December 2020 BAR Action

Certificate of Appropriateness Application

BAR 20-12-02

201 East Market Street

NW corner aerial view (east side)—Proposed pipes and conduit (for context only)

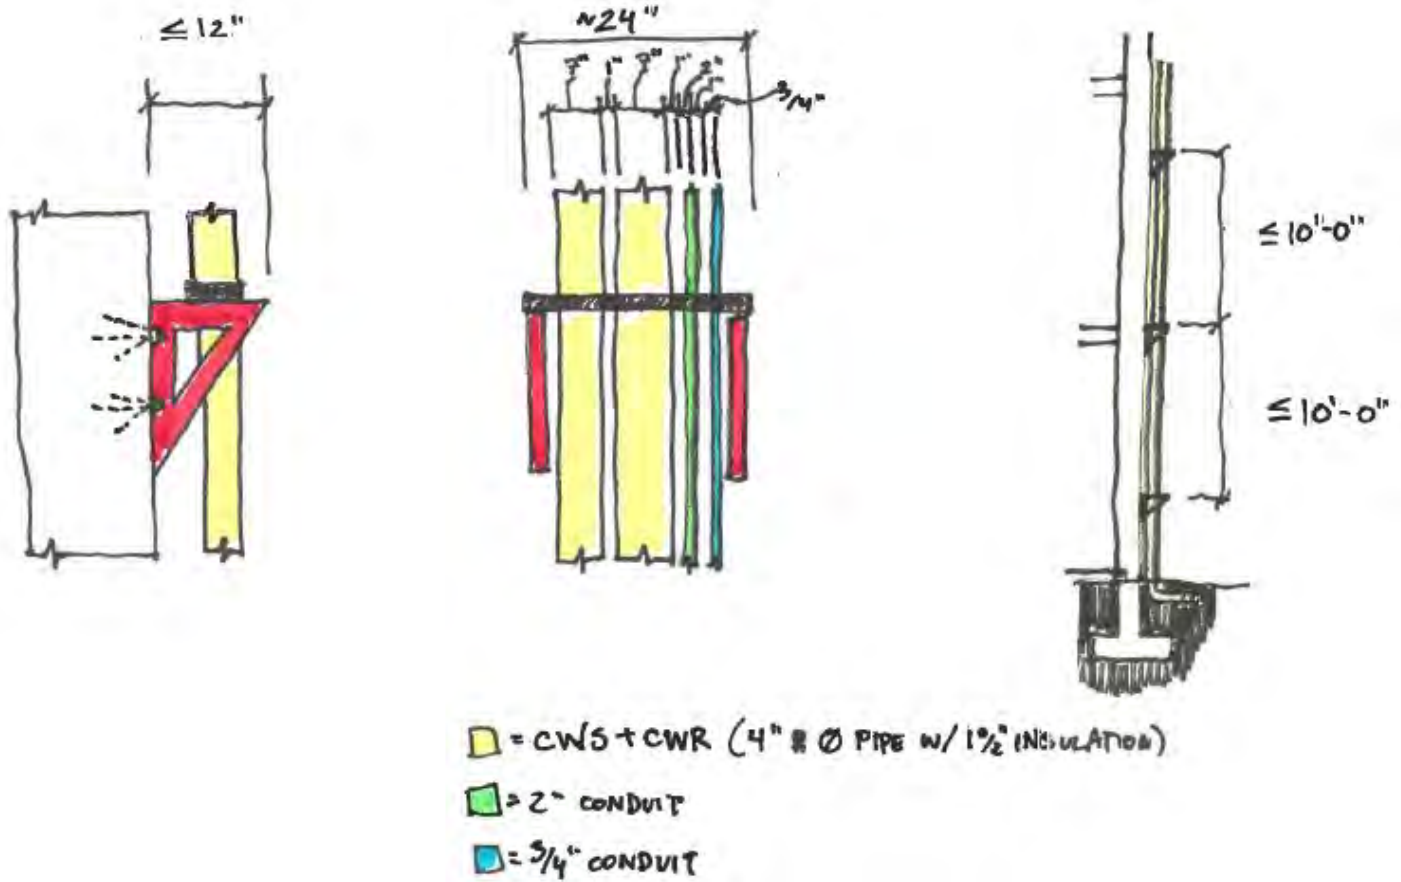
Cheri Lewis moves: Having considered the standards set forth within the City Code, including the City's ADC Design Guidelines, I move to find that the proposed rooftop units and exposed pipes and conduits satisfy the BAR's criteria and is compatible with this property and other properties in the North Downtown ADC District, and that the BAR approves the application as submitted, with the following condition:

- *that the conduits be painted a close color to the existing brick to be approved by staff*

In reviewing this project with the applicant, the proposed routing of the exposed pipes and conduits. Alternatives were evaluated, but were constrained by limited space and routing options within the building, avoiding areas with asbestos, and conflicts with egress, among other issues. Staff is confident that the request presents the most feasible routing solution.

Staff recommends the BAR approve the proposed location (routing), with four options for addressing the visible pipes and conduits.
